Title: **QUALITY AUDIT (Stage 1)**

**Proposed Strategic Housing Development At Carmanhall
Road, Sandyford Industrial Estate, Dublin 18.**

Client: **AECOM**

Report reference: **0951R01**

3.1 Problem

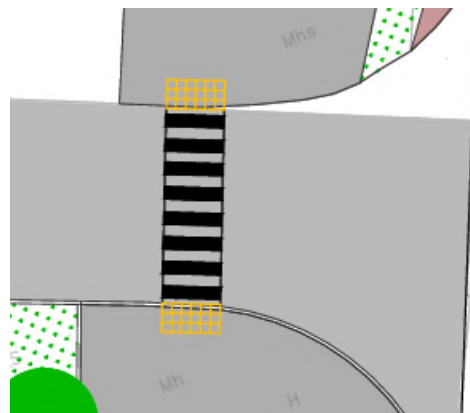
It is proposed to relocate the signalised pedestrian crossing on Carmanhall Road to the eastern side of the new vehicular access. The proposed location coincides with an emergency access route to the building on the opposite side of Carmanhall Road. The signal heads and location of other street furniture could block the route of emergency vehicles.

It is recommended that the crossing be located where it does not interfere with access for emergency vehicles.

3.1	Y	Y	The design team are currently engaging with Dun Laoghaire Rathdown Traffic and Parks Department to integrate the scheme proposals in with the proposed works to both Carmanhall Road and Blackthorn Road. During the detailed design stage, the issue raised will be taken into account and the necessary stakeholders consulted when preparing the final design.	Yes

3.2 Problem

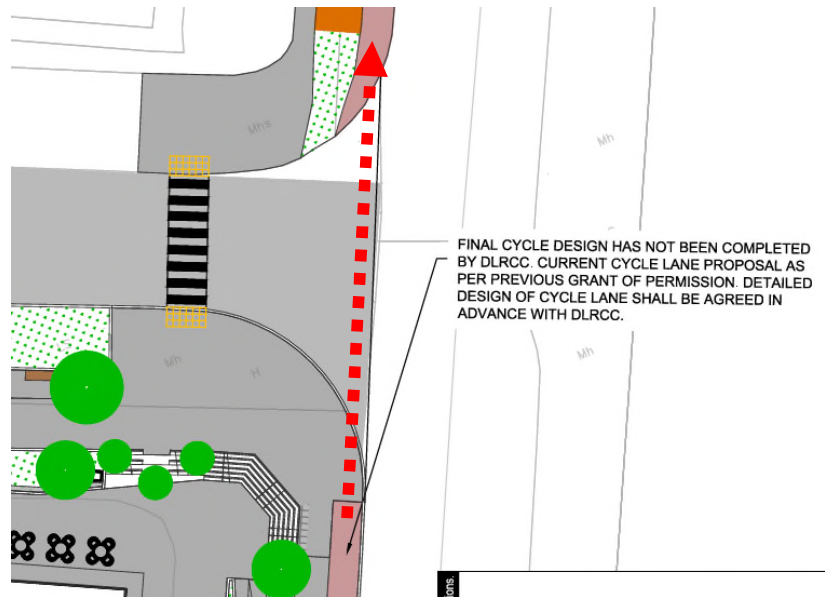
The uncontrolled pedestrian crossing shown on Carmanhall Road close to the Blackthorn Road junction is shown to have black and white stripes. This may lead to confusion between drivers and pedestrians. Pedestrians may think that they have priority as the striped markings resemble a controlled zebra crossing however there are no belisha beacons and drivers may assume that pedestrians will wait on the footpath until they pass. The confusion could lead to collisions.

It is recommended that the stripes be removed. Similarly the stripes on the access road to the car park should be removed.

3.2	Y	Y	The uncontrolled crossing adjacent to the Carmanhall Road / Blackthorn Road junction has had the line markings removed.	Yes
3.3	Y	Y	The design team are currently engaging with Dun Laoghaire Rathdown Traffic and Parks Department to integrate the scheme proposals in with the proposed works to both Carmanhall Road and Blackthorn Road. During the detailed design, the issue raised will be taken into account when preparing the final design.	Yes

3.4 Problem

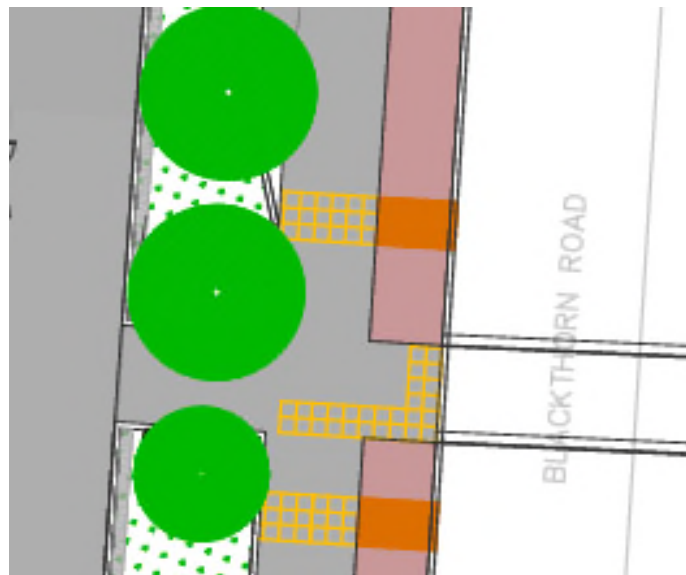
There is no facility for cyclists to turn right from the existing cycle track on Blackthorn Avenue into Carmanhall Road. Without an area for cyclists to wait and then get onto the carriageway to facilitate turning could result in cyclists preferring to stay on the carriageway rather than use the cycle facilities.

It is recommended that waiting facilities (jug turn or similar) and turning facilities (dropped kerbs) are provided for right turning cyclists.

3.4	Y	Y	The design team are currently engaging with Dun Laoghaire Rathdown Traffic and Parks Department to integrate the scheme proposals in with the proposed works to both Carmanhall Road and	Yes

3.5 Problem

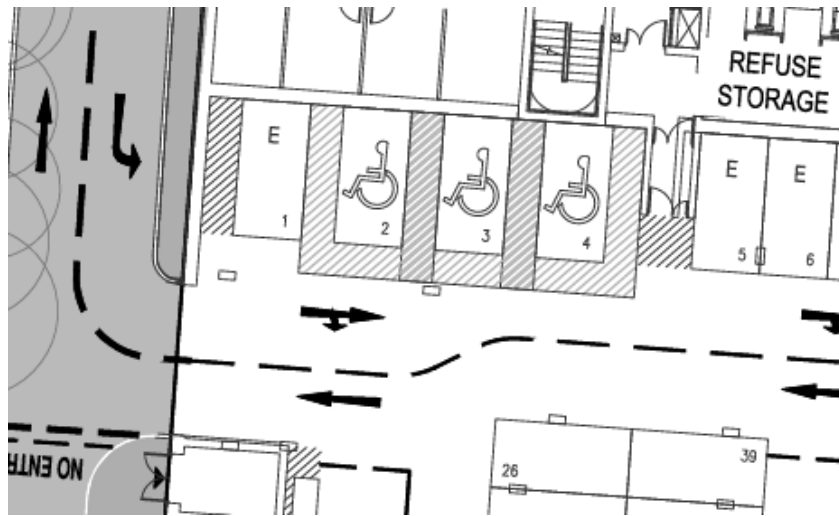
There is an existing signalised pedestrian crossing of Blackthorn Road on the northern side of the Burton Hall Road junction. Given the proposed cycle lane on Blackthorn Road and the anticipated increase in cycling generated by the proposed development there is a risk that the pedestrian crossing will be used by cyclists which may lead to collisions with pedestrians.

It is recommended that the pedestrian crossing be upgraded to a toucan crossing.

3.5	Y	Y	The design team are currently engaging with Dun Laoghaire Rathdown Traffic and Parks Department to integrate the scheme proposals in with the proposed works to both Carmanhall Road and Blackthorn Road. During the detailed design, the issue raised will be taken into account when preparing the final design.	Yes

3.6 Problem

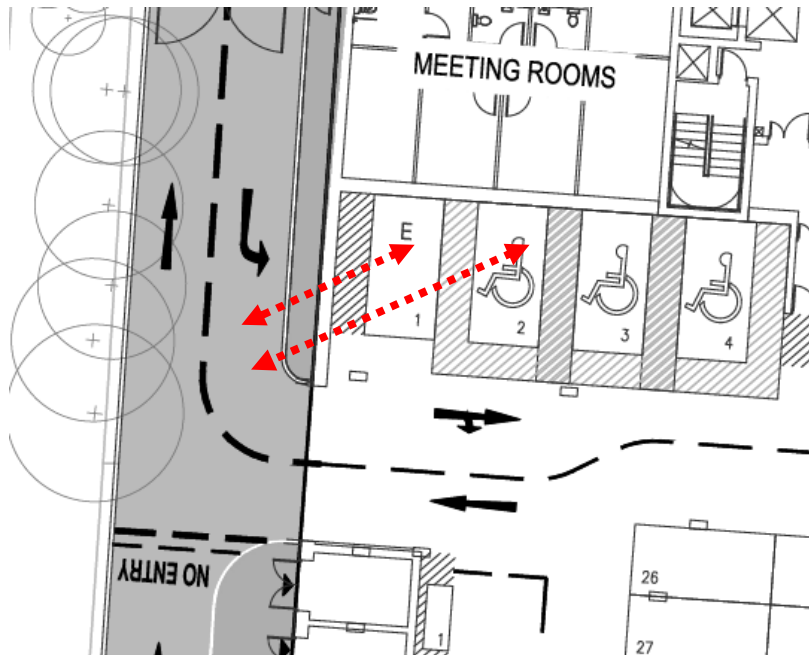
The buffer zone around disabled parking spaces 3, 4, 36, 49, 95 & 96 extend into the carriageway. If vehicles are travelling over this area then there will be no room for disabled users to occupy this space for accessing their vehicle.

It is recommended that the buffer zones do not overlap with the driving aisle as per the guidance provided in Part M of the Building Regulations.

3.6	Y	Y	The car park layout has been revised from 2 way to 1 way which ensures that adequate space is provided to ensure that vehicles will avoid the buffer areas	Yes

3.7 Problem

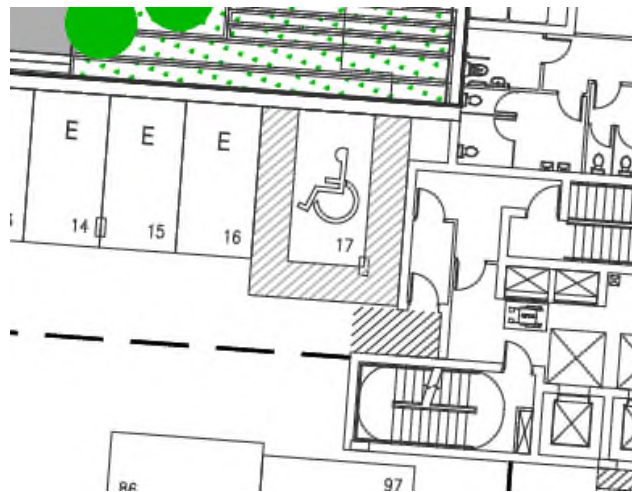
It is unclear if drivers exiting EV space no. 1 and disabled space no. 2 will have suitable visibility to vehicles entering the car park. Without suitable visibility there is a risk of rear-end collisions.

Ensure that there is sufficient visibility for drivers exiting these spaces.

3.7	Y	Y	An ope is to be provided along the wall to the west of car parking space no. 1 to ensure that drivers can observe vehicles reversing from these spaces.	Yes

3.8 Problem

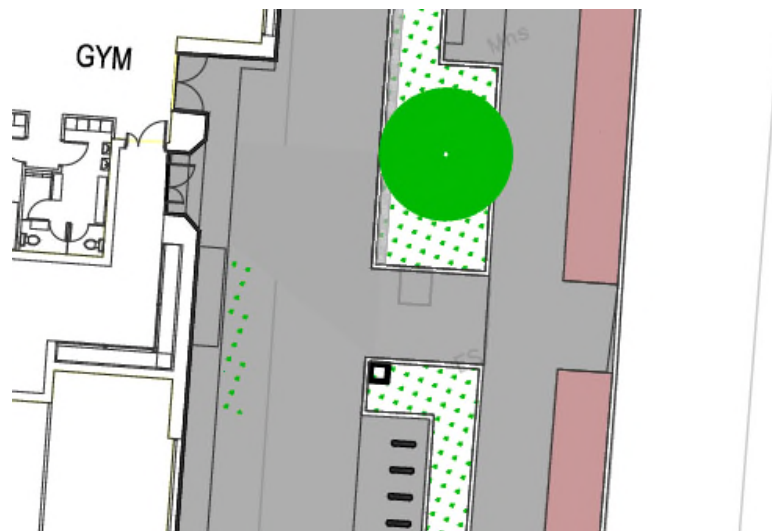
It is unclear if a driver using disabled parking space no. 17 would be able to exit from this space without colliding with the stair core.

It is recommended that disabled space no. 17 be relocated. The potential of limited neck movement of drivers should be taken into account when locating disabled parking bays.

3.8	Y	Y	An autotracking assessment has been undertaken of these spaces and the scheme drawings have been updated accordingly	Yes
3.9	Y	Y	Cycle lane has been continued at this location	Yes

3.10 Problem

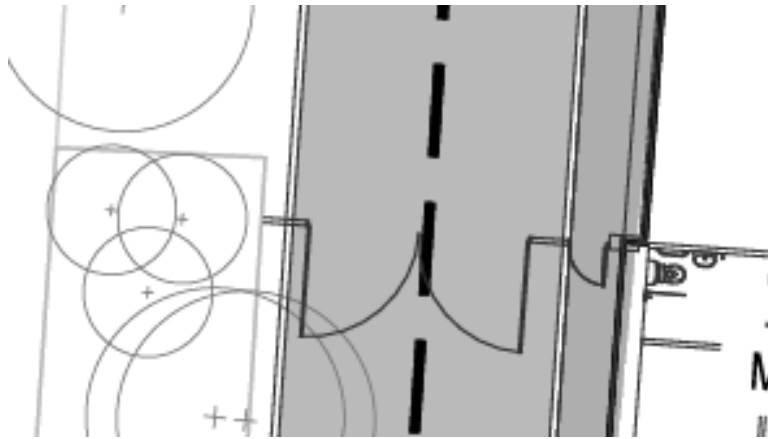
There will be a pedestrian desire line from the access to the development beside the Gym to the bus stop on the opposite side of Blackthorn Road. There is no signalised crossing of Blackthorn Road along this desire line.

It is recommended that a signalised pedestrian/toucan crossing be incorporated into the traffic signals at the southern side of Blackthorn Road/Burton Hall Road junction.

3.10	Y	Y	The design team are currently engaging with Dun Laoghaire Rathdown Traffic and Parks Department to integrate the scheme proposals in with the proposed works	Yes

3.11 Problem

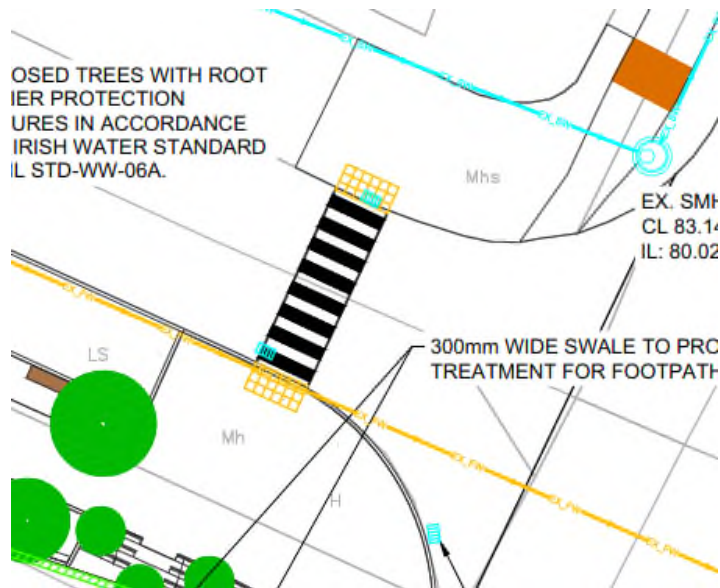
There is a risk that the posts for the gates at the entry to the car park could be scraped by passing vehicles as two vehicle try and ‘squeeze’ past at the local narrowing of the effective carriageway width.

It is recommended that the gate posts be kept outside the carriageway.

3.11	Y	Y	Gate posts have been set back at this location as specified.	Yes
3.12	Y	Y	The design team are currently engaging with Dun Laoghaire Rathdown Traffic and Parks Department to integrate the scheme proposals in with the proposed works to both Carmanhall Road and Blackthorn Road. The crossing has been moved to take account of the gullies at this location with the gully on the north side of Carmanhall Road to be relocated upstream of the crossing as requested.	Yes

3.13 Problem

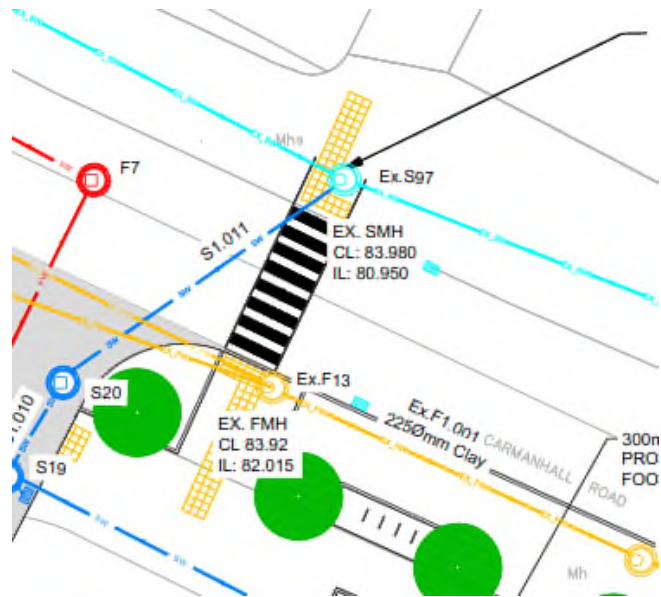
There is a risk that the provision of dropped kerbs at the proposed signalised pedestrian crossing on Carmanhall Road could lead to surface water ponding at the crossing which in turn could lead to slips and falls particularly in wet or icy conditions.

It is recommended that the gullies be provided upstream of the crossing area.

3.13	Y	Y	The design team are currently engaging with Dun Laoghaire Rathdown Traffic and Parks Department to integrate the scheme proposals in with the proposed works to both Carmanhall Road and Blackthorn Road. During the detailed design, the issue raised will be taken into account when preparing the final design.	Yes

3.14 Problem

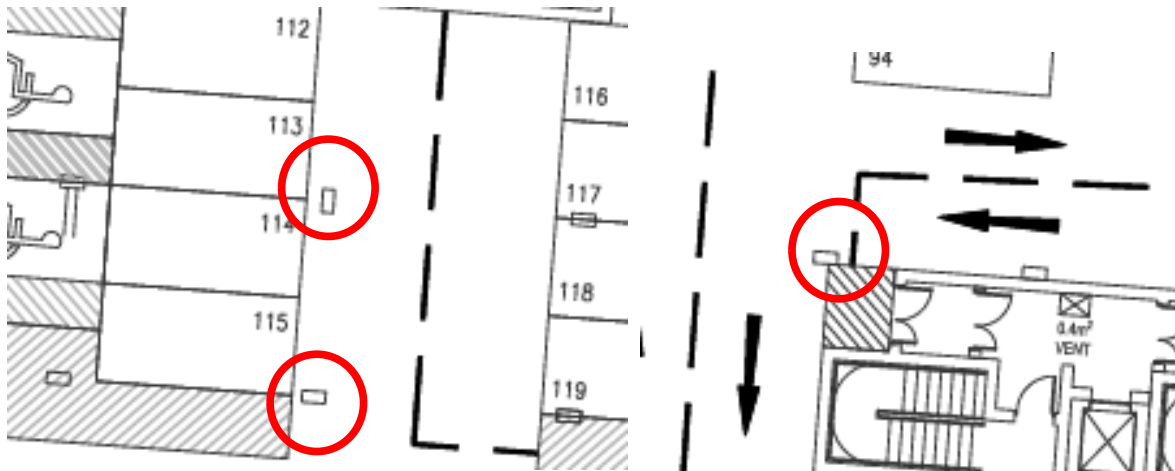
Some structural columns appear to be within the parking spaces and carriageway of the car park. These would be hazards for parking and driving on the aisles.

It is recommended columns are not within parking spaces and within the carriageway of the car park.

3.14	Y	Y	An autotracking assessment has been undertaken and these spaces have been checked to ensure that vehicles can enter and exit safely. Columns have been relocated and the car park has been altered to a one-way only	Yes
